NORTH LANTAU EXPRESSWAY

**Environmental Assessment Report
Tung Chung Section
Final Report
Agreement No. CE/18/81**

Government of Hong Kong
Highways Department

March 1992

Figure 1.2
Typical Cross Section of the NLE

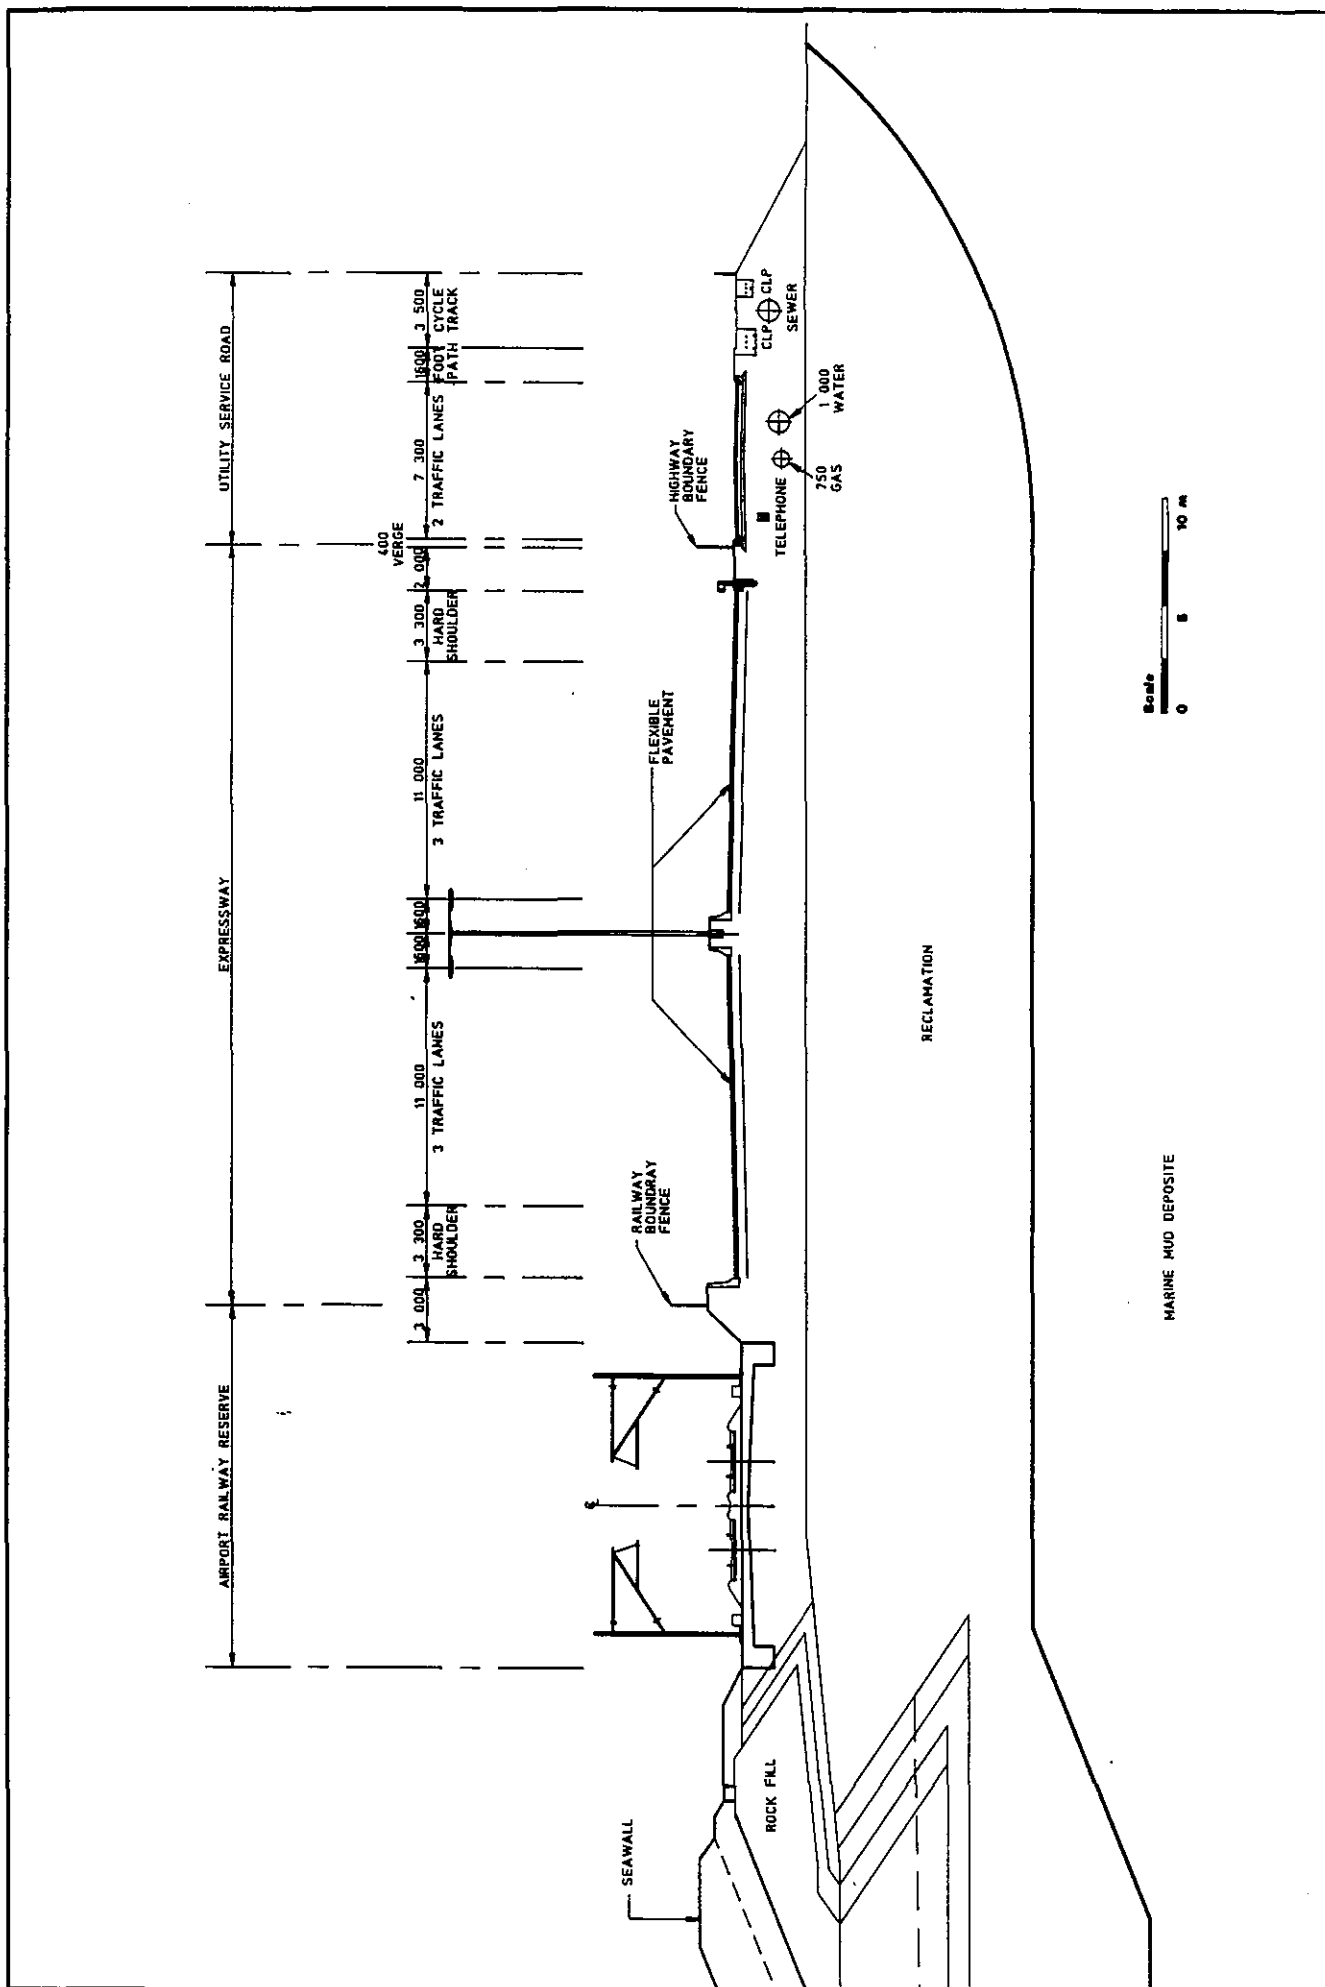
(i) Figure 1.2 is the 'baseline' cross-section of the NLE not the 'typical' one for the NLE Tung Chung section. This needs to be explained and the actual sections shown in the final version of the report.

Figure 4.4
Selected Sections for Noise Contour Plots

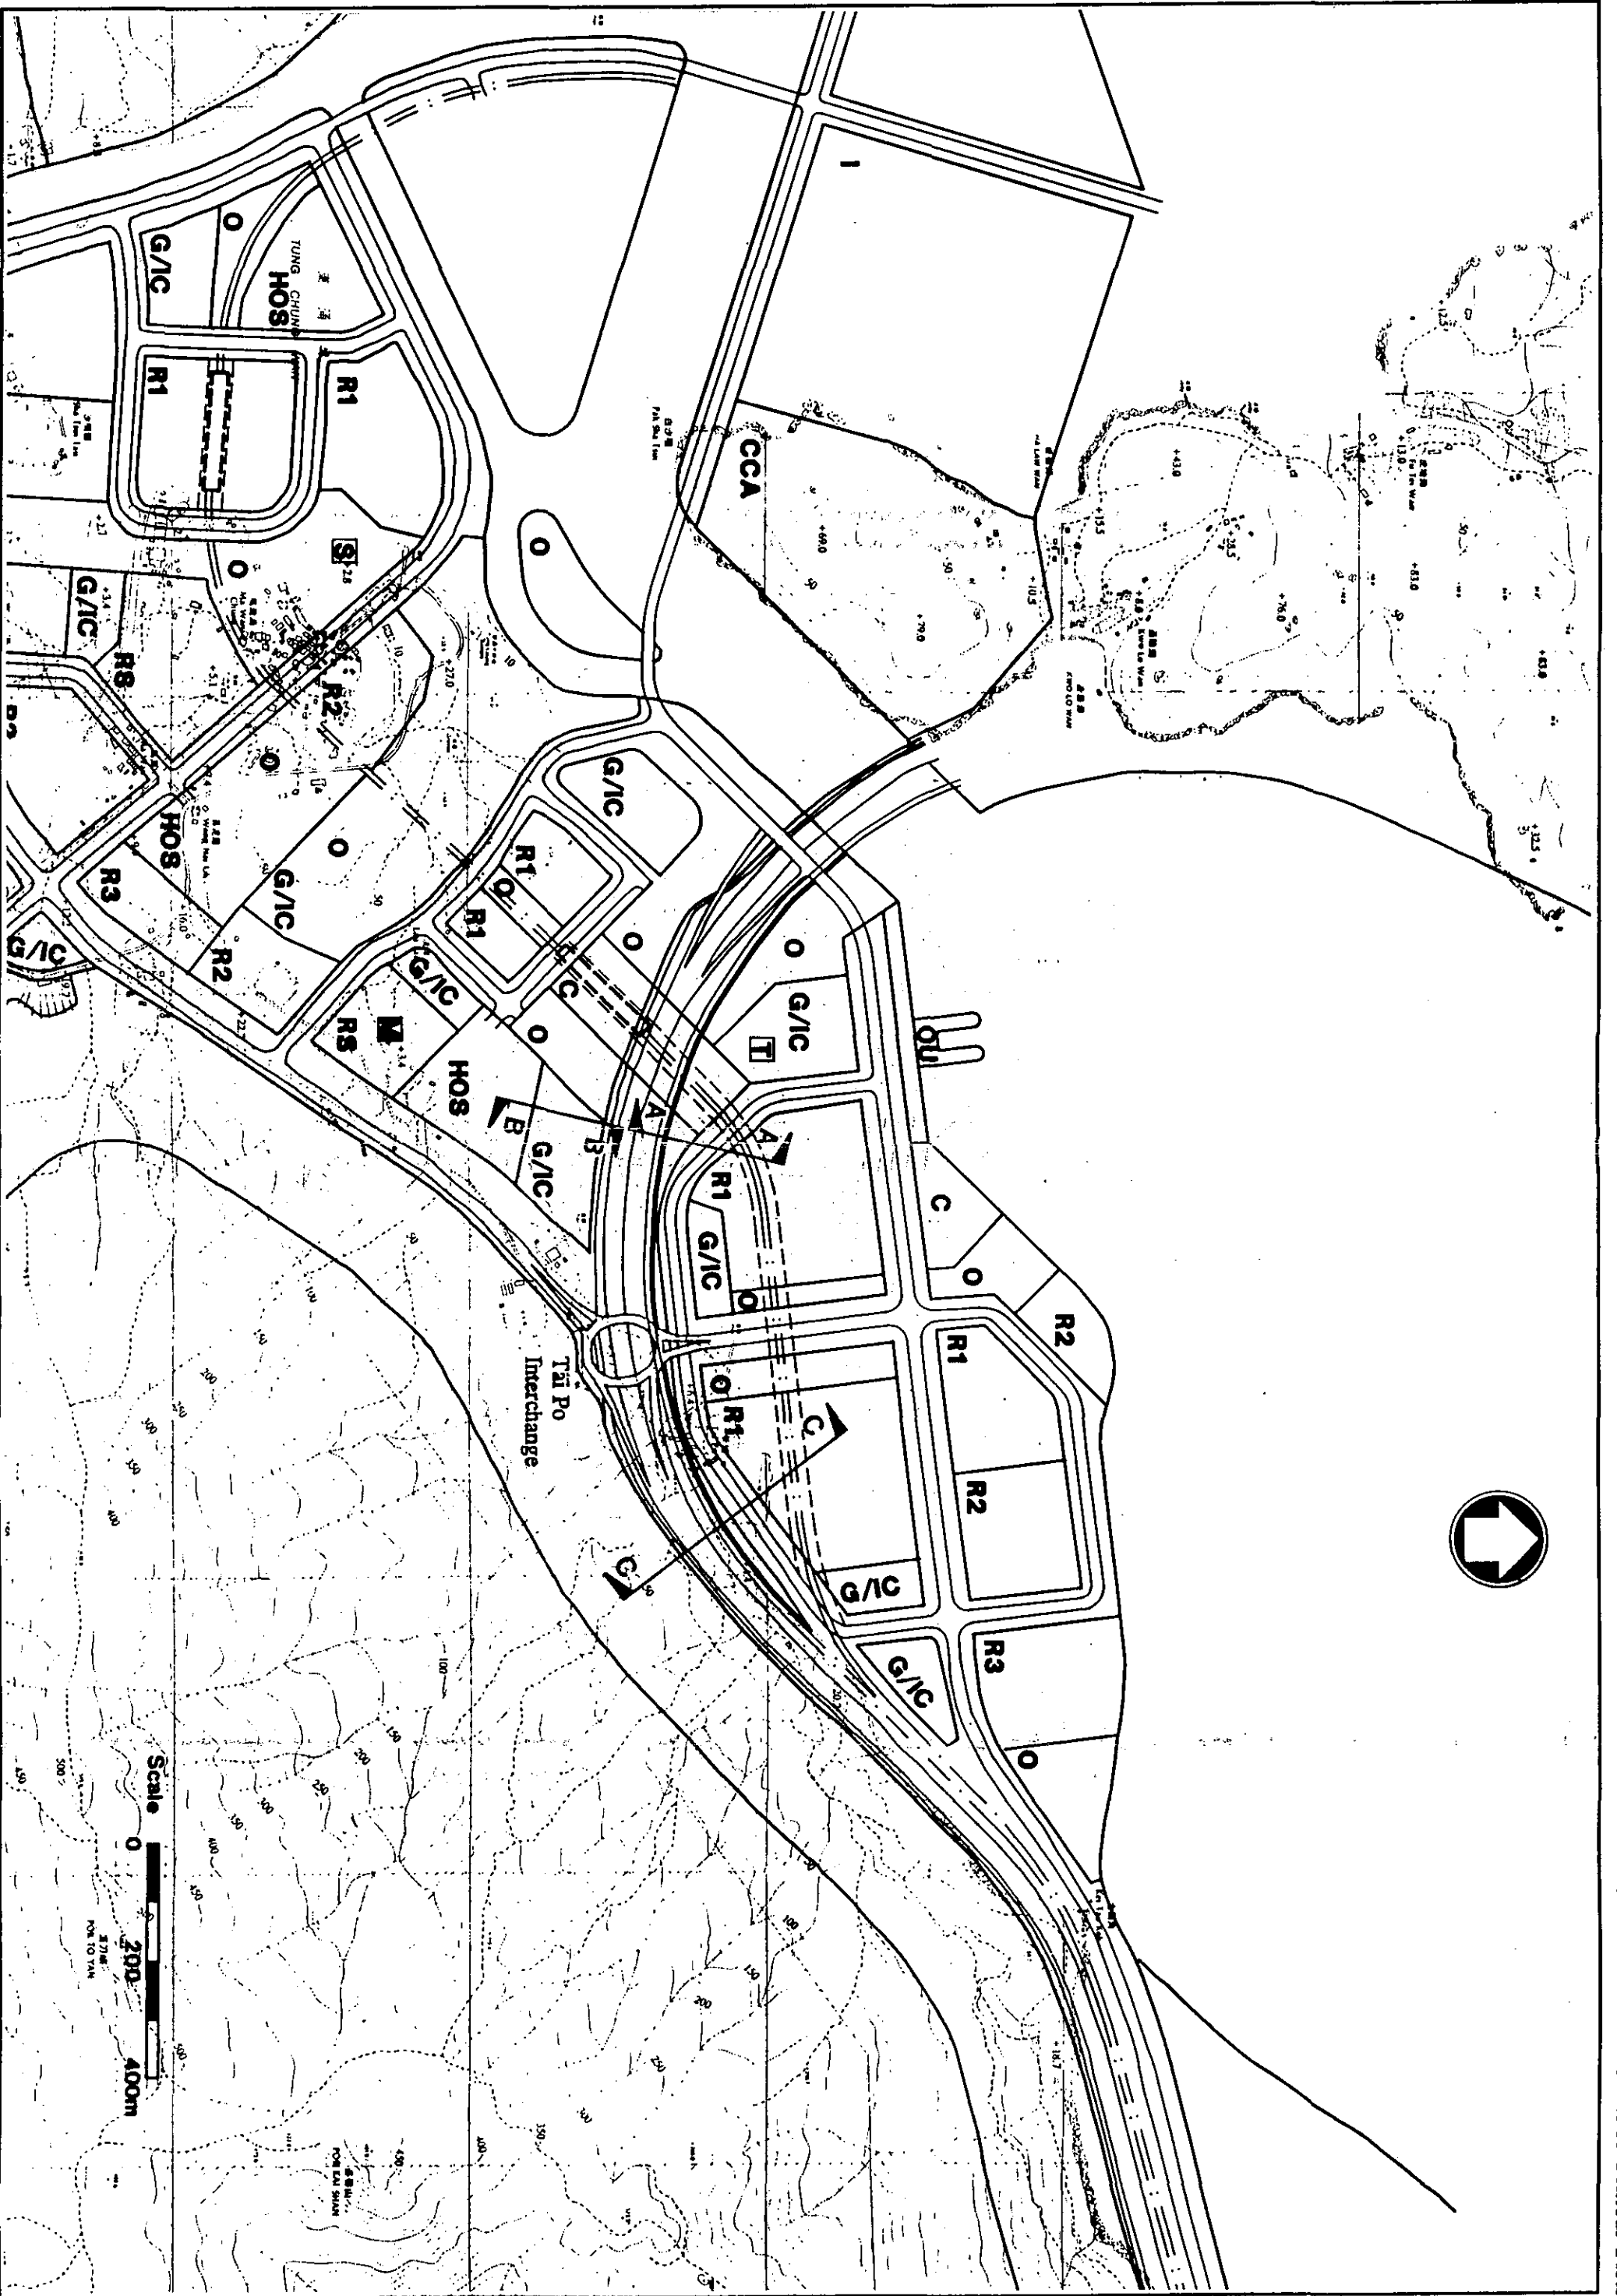
- (iv) The selected sections for noise contour plots shown on Figure 4.4 should be reproduced in the final version of the report ie as per the Interim RODP phase I planning layout for the NLE/AR corridor.

- (v) Figures 4.2-4.4 are based on the draft RODP which has already been superseded by the Interim RODP. For example, the NLE/AR corridor is now elevated across primary distributor P1. Does this change affect the noise contour plots shown on Figures 4.5-4.7?
